4702 West Virginia Ave, Sketch Plan No. 320190060

Completed: 5/23/2019

Description

Figure 3: Proposed Sketch Plan

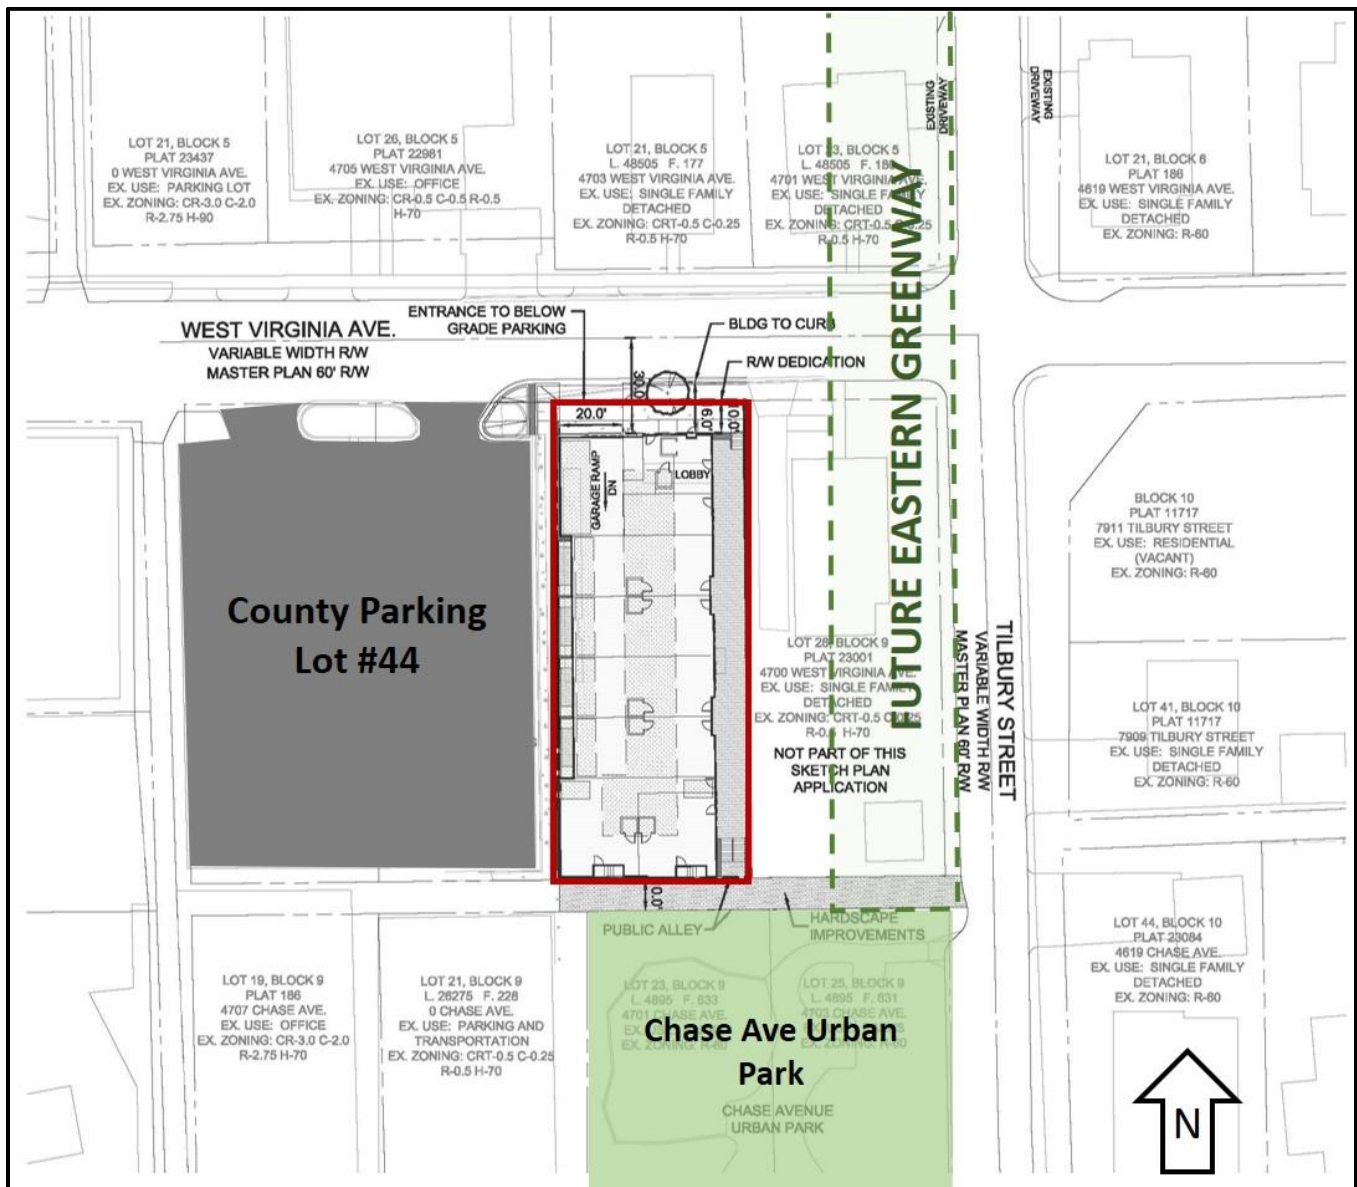
- a. Submit alternative designs that show façade treatments and site layouts for redevelopment scenarios that include the abutting property on the corner of West Virginia Ave and Tilbury Street and those that do not;

- b. Explore ways to improve the western façade by adding architectural elements to avoid blank walls;
- c. Integrate design improvements as requested by Design Advisory Panel;

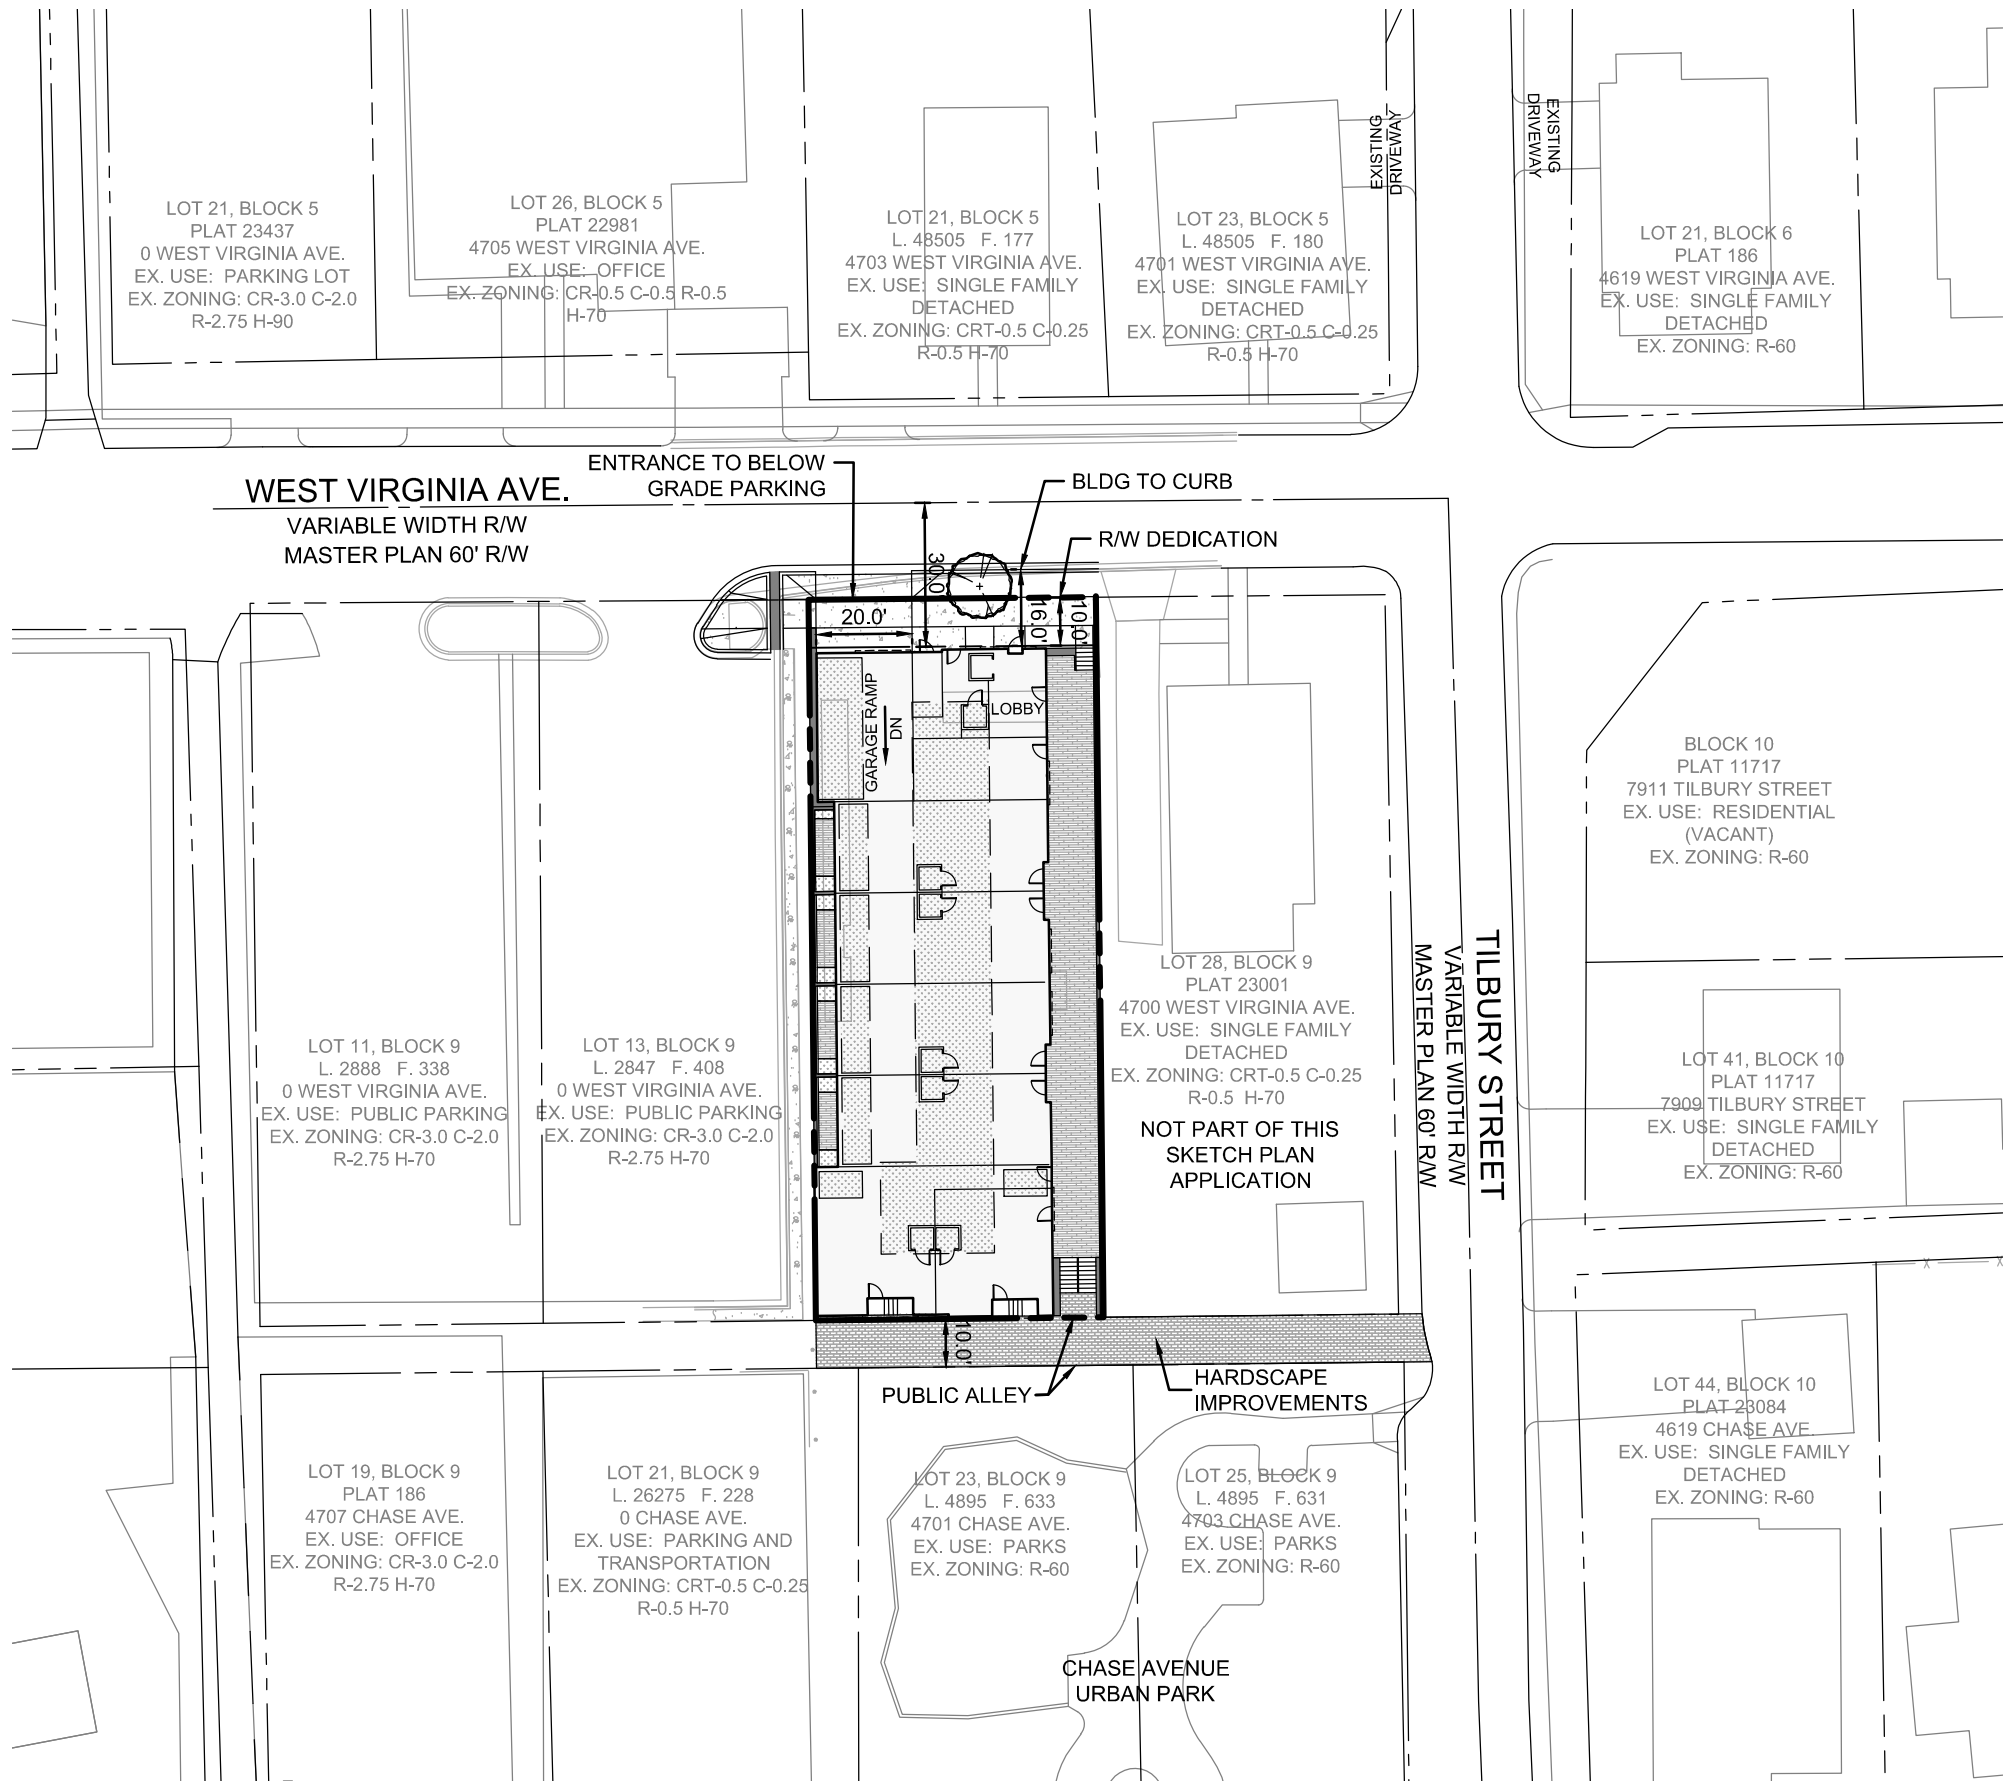
- So, the back of units and back of building are on the potential future park on the west side.

- The building is so tight and narrow based on the property width, and there are not windows. More building width would give more flexibility. Need more intermediate space between the project and adjacent parks.

- West elevation should be designed and articulated, no blank panels. Balconies, windows and no blank walls.
- For the portion facing chase avenue urban park the plantings are on the paper alley and the project should consider a larger setback for a transition to the park and an improved entry.

- The elevation seems very flat, need to add depth to the grey elements.
- At site plan would like to see something more detailed and articulated.
- Consider small projections and balconies on rear.

- *Applicant Response: They might be pavers and potted plants. We might be able to achieve what you are discussing in the alley.*
- If it has to remain as a lawn or paving you need to have a front, a semi-public front.
